**SELECTIVE  
MODIFICATIONS  
TO**

150 WORTH AVE  
PALM BEACH UNIT 136  
FLORIDA 33480

### RFI 136

**A1**

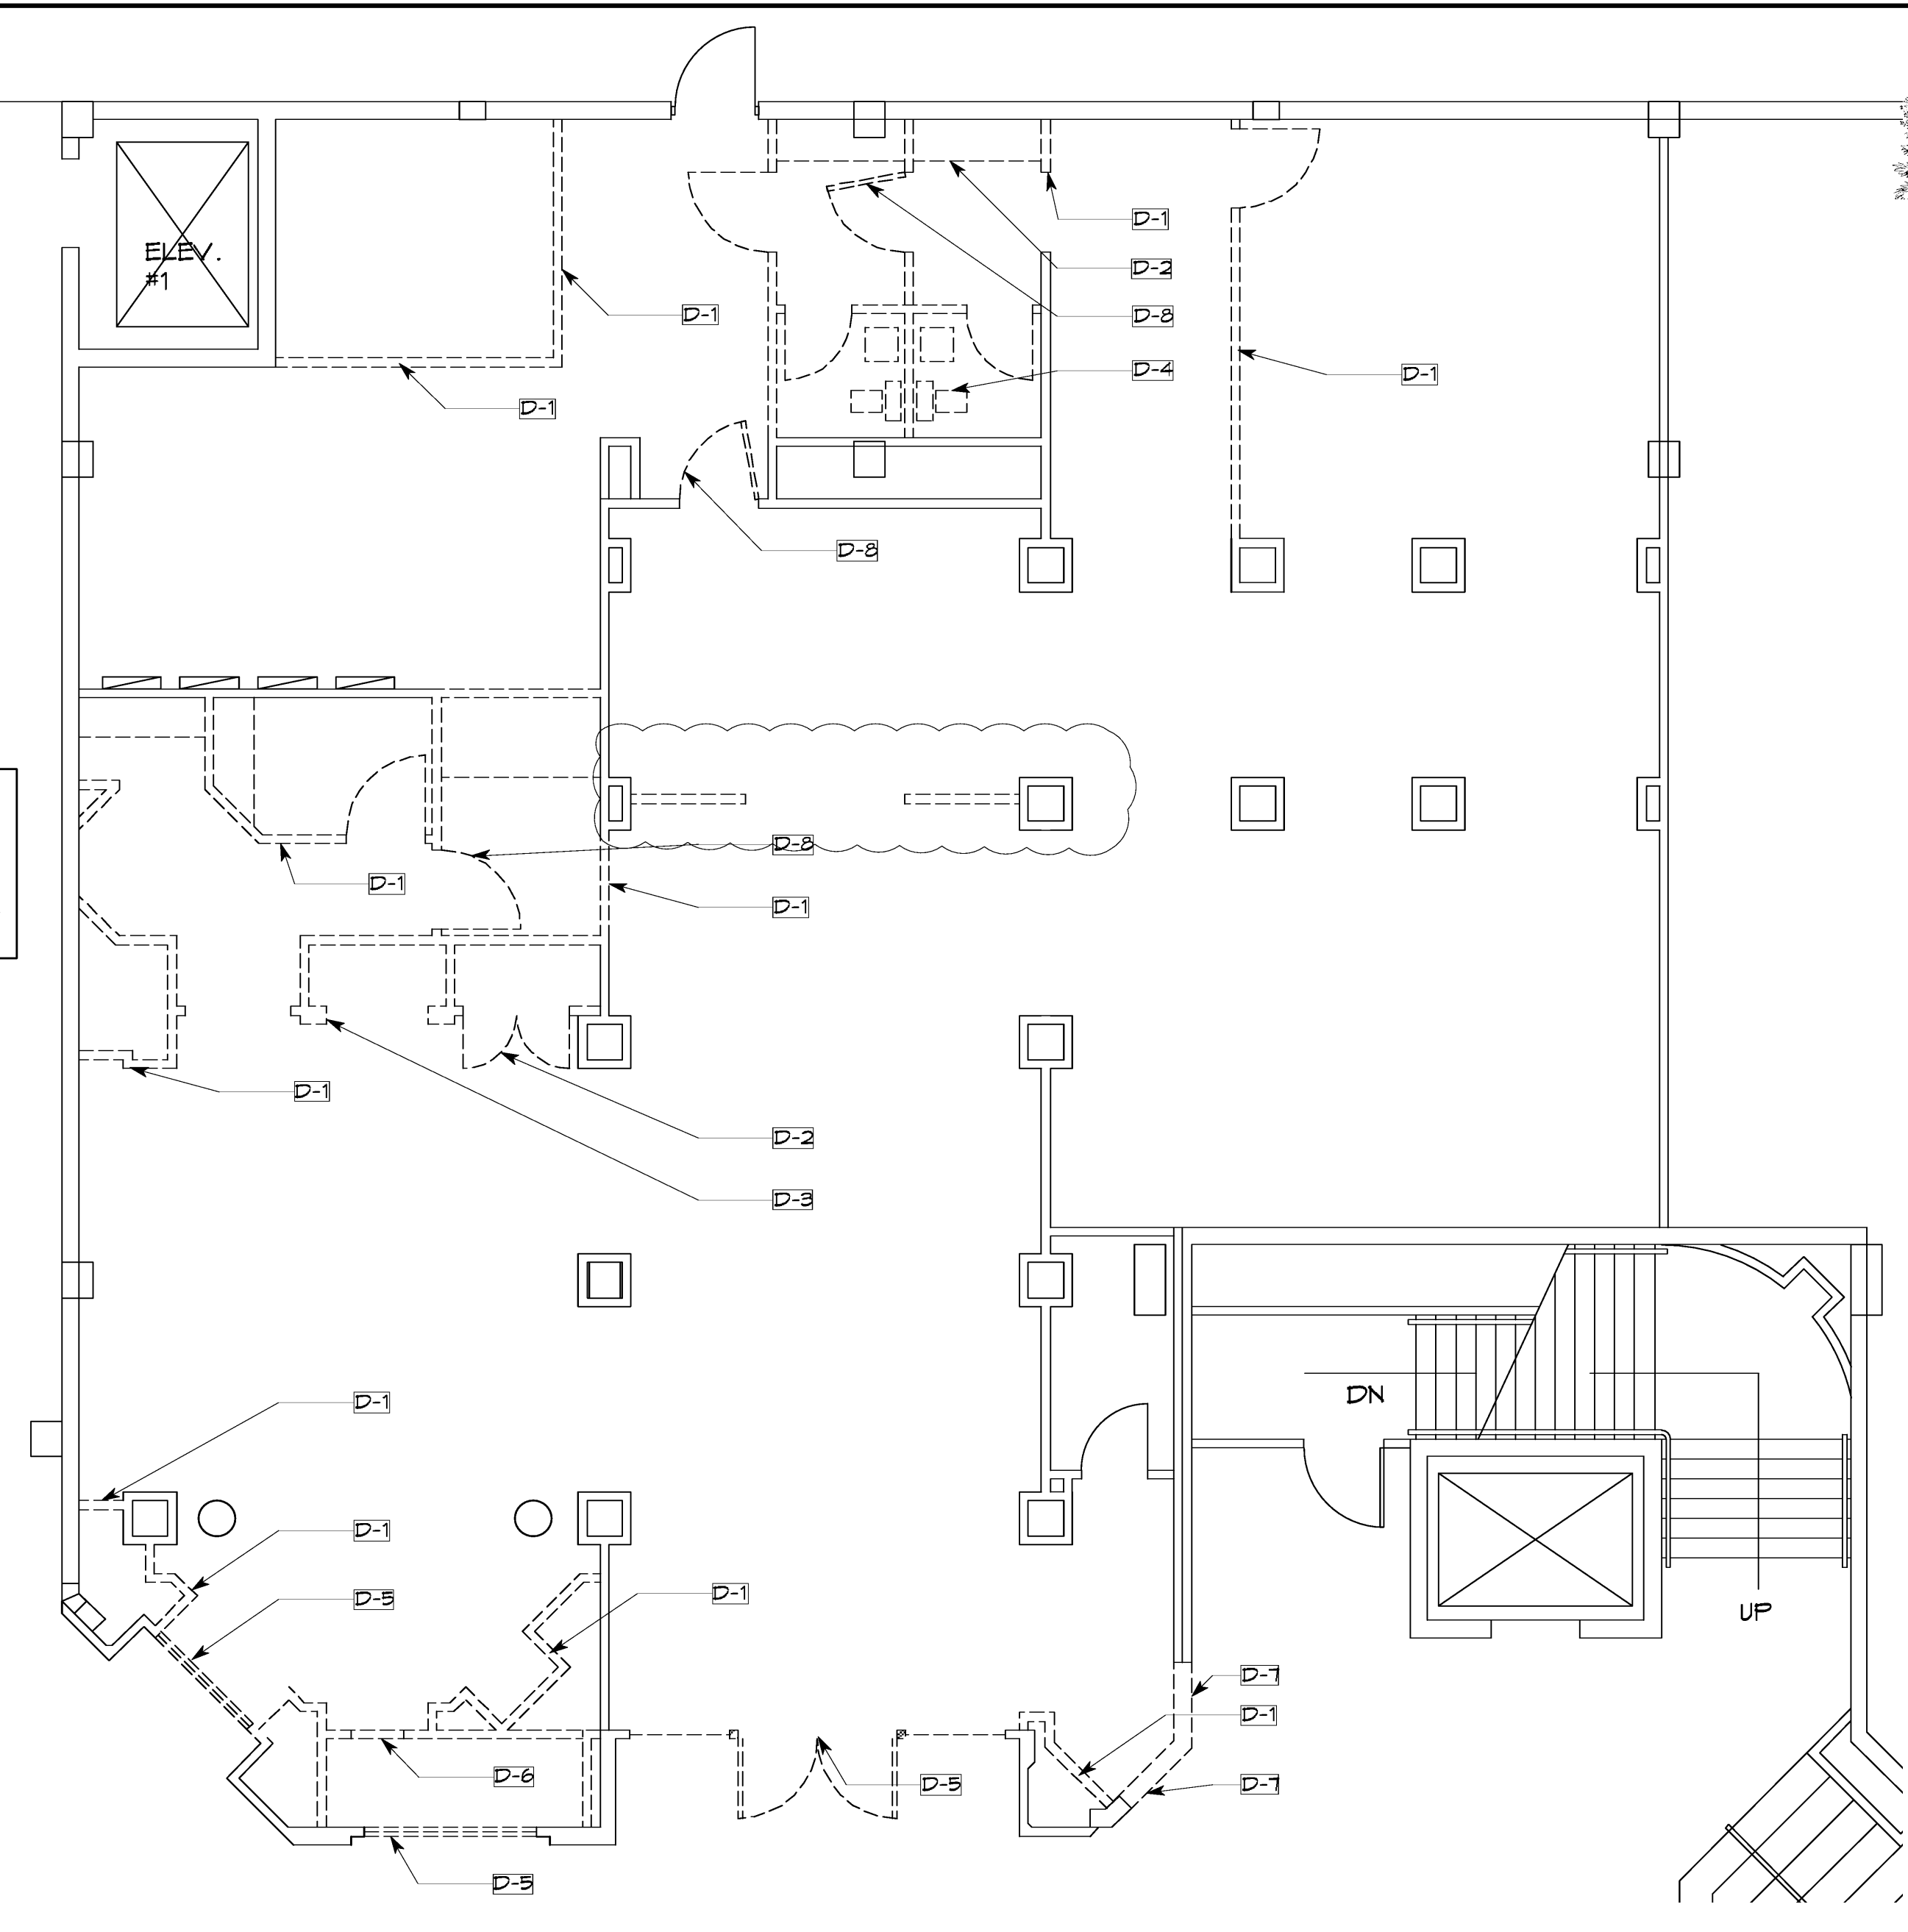
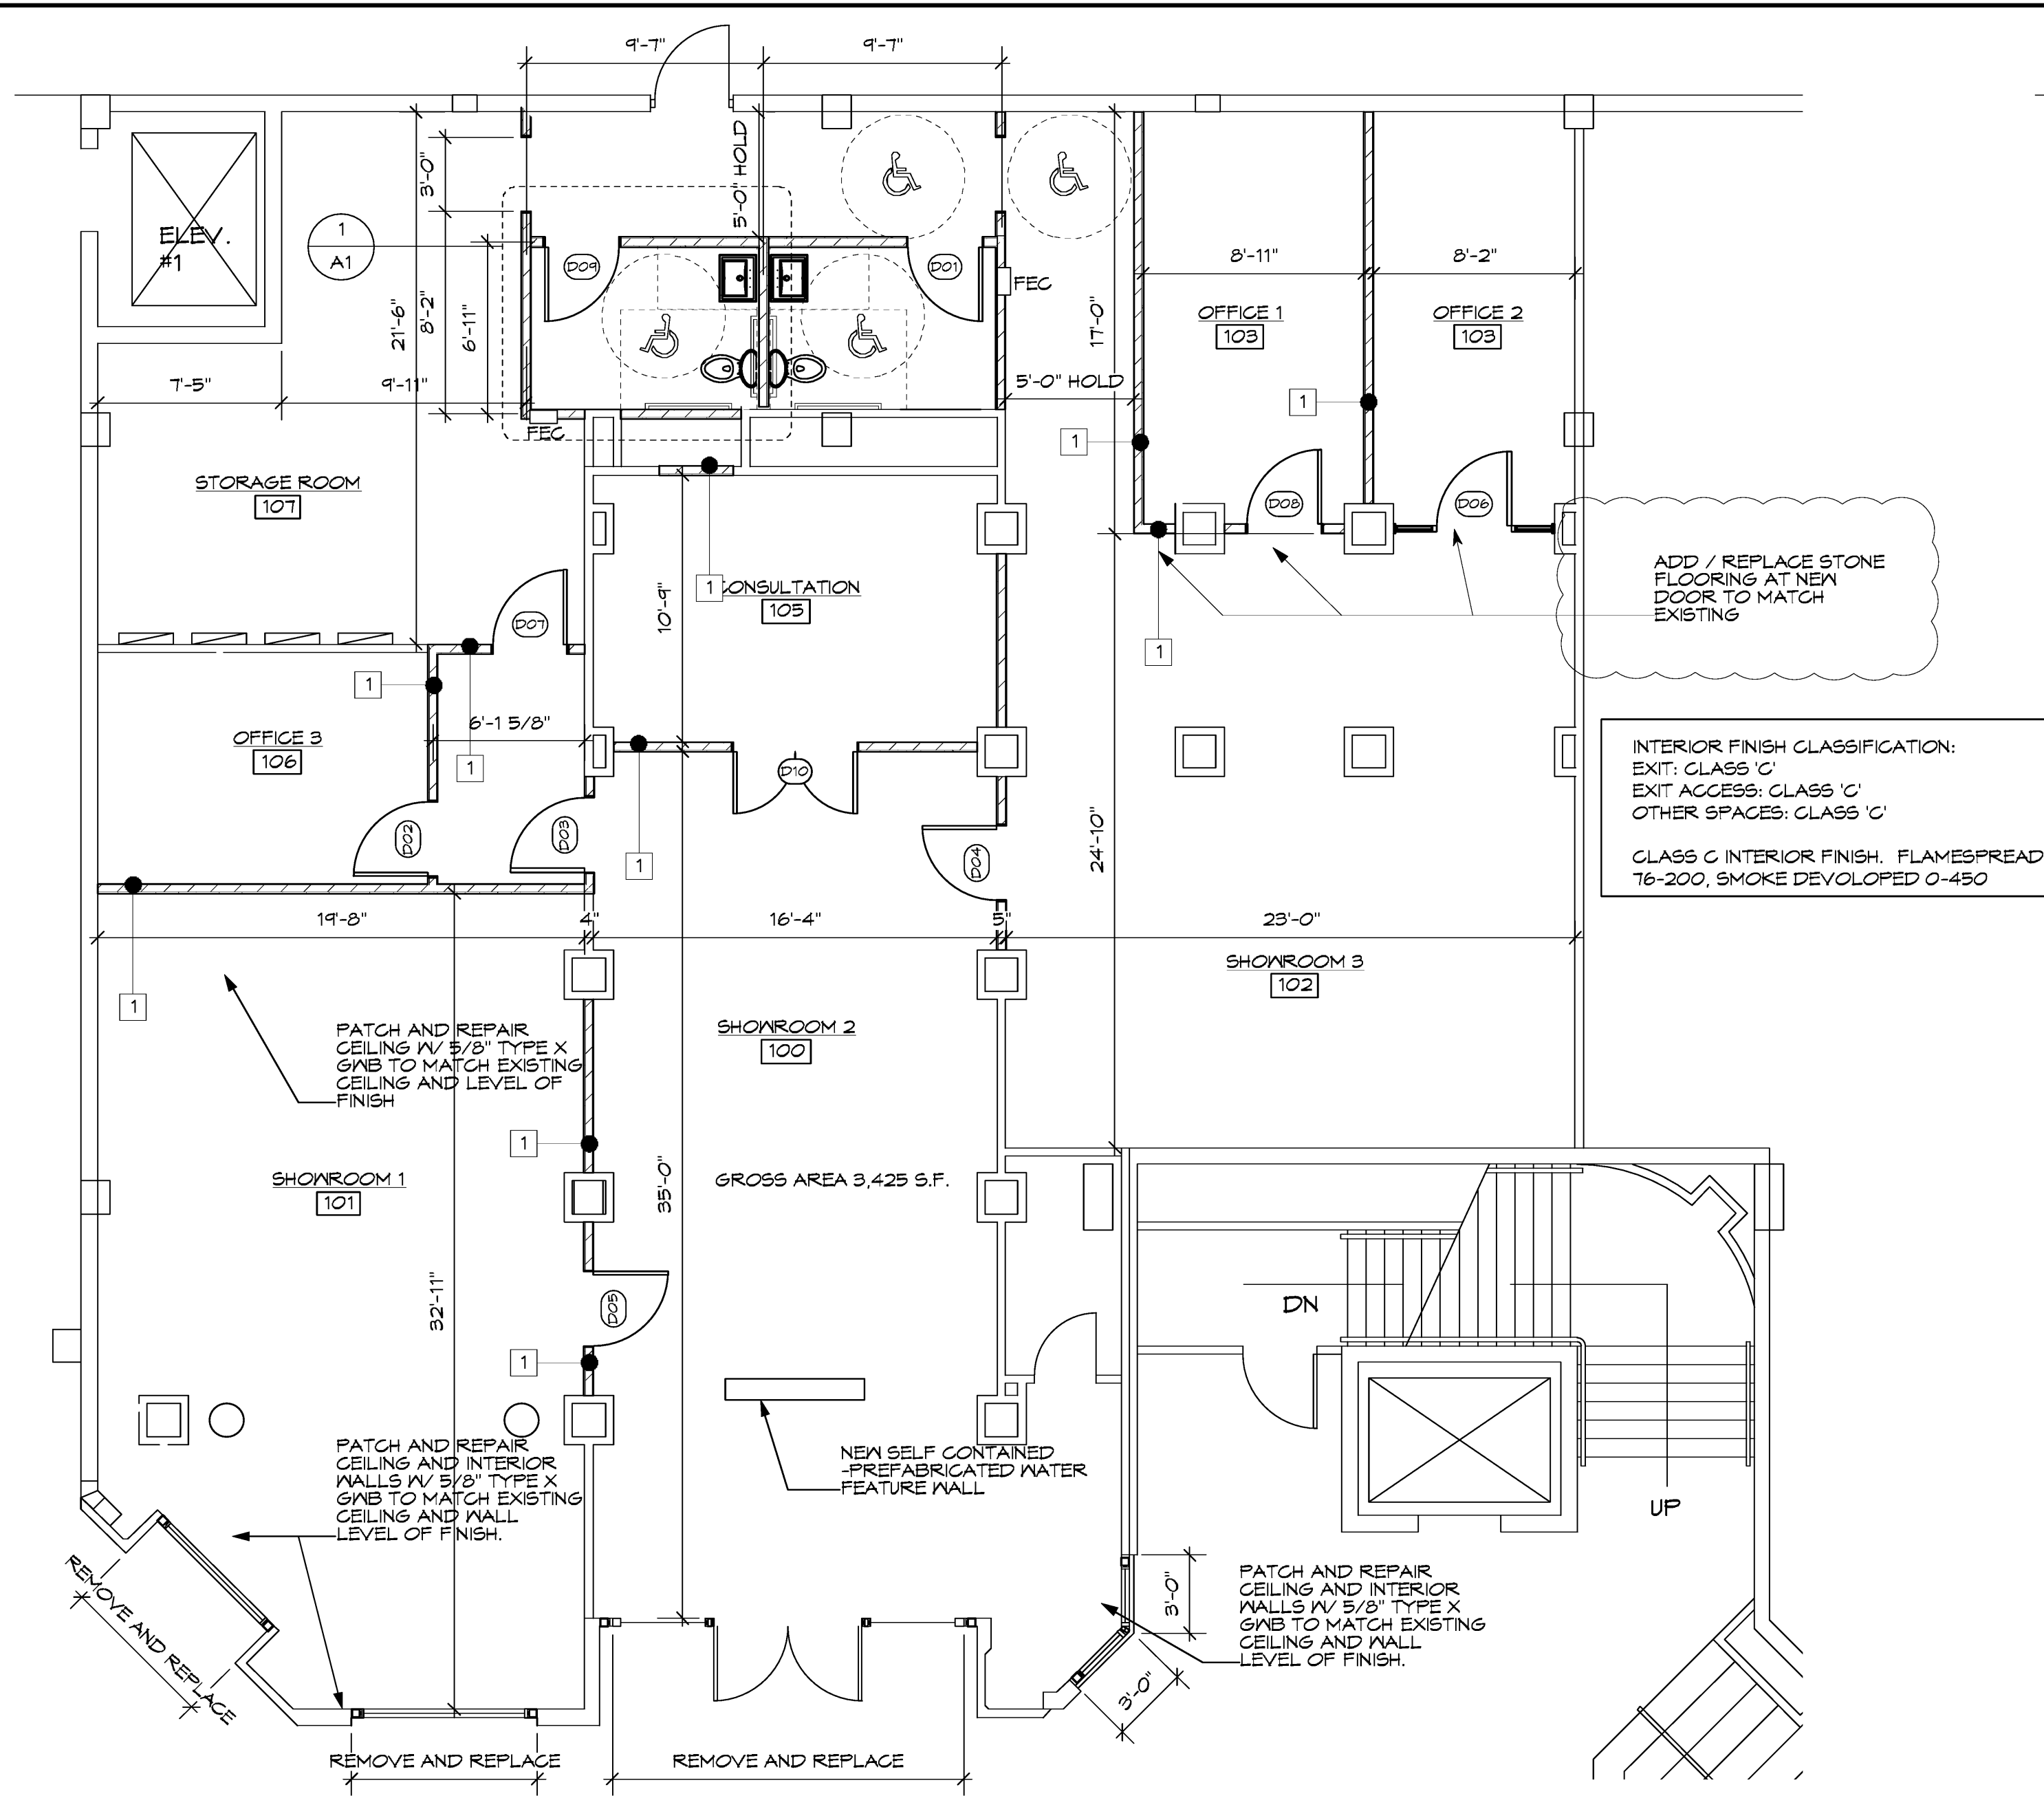
2. Are the walls to be built to the existing ceiling or are they to pass through the existing ceiling and the ceiling patched up to the new wall. **WALLS SHALL EXTEND 6" ABOVE CEILING. BRACE TO STRUCTURE @ 48" O.C. SEE SHEET A1**

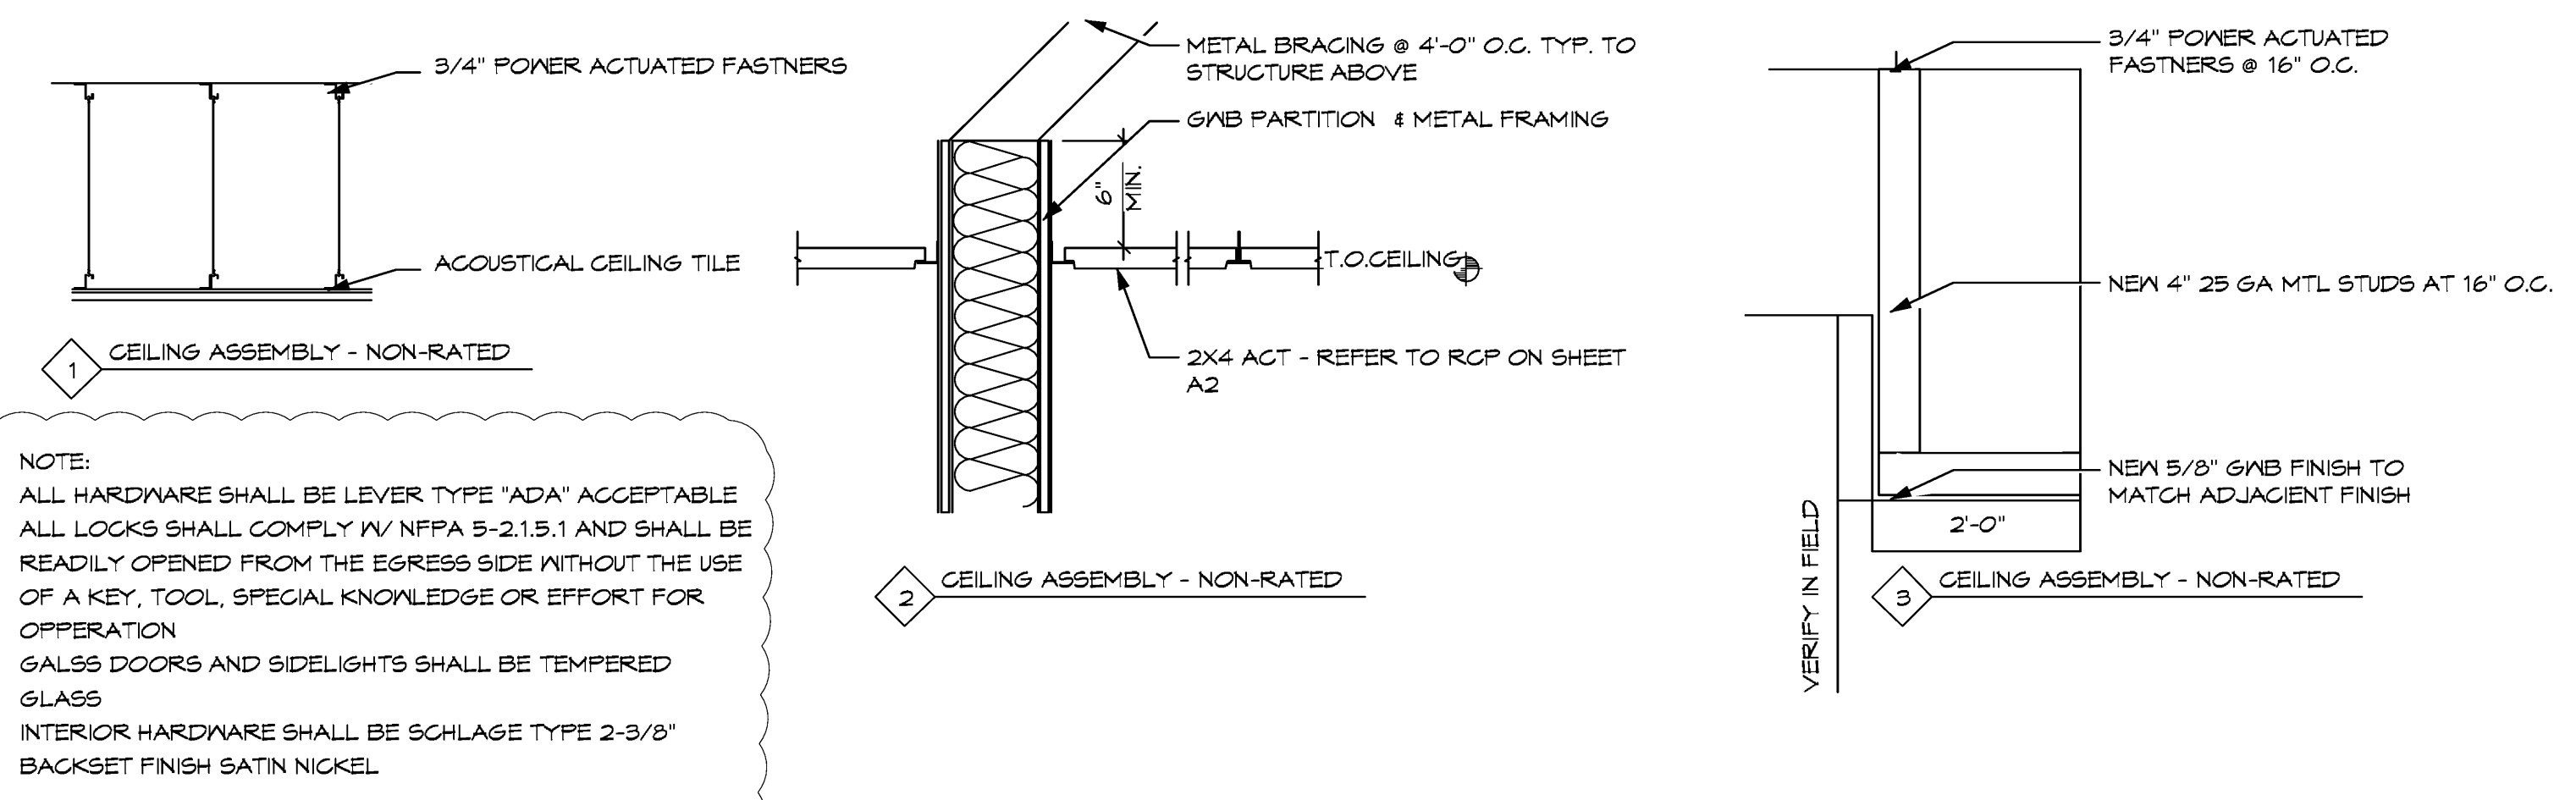
There is no demolition plan associated with the removal of the storefront system and associates components. Will any shoring be required prior to the removal of the existing storefront assembly? **SEE DEMO PLAN SHEET A1**
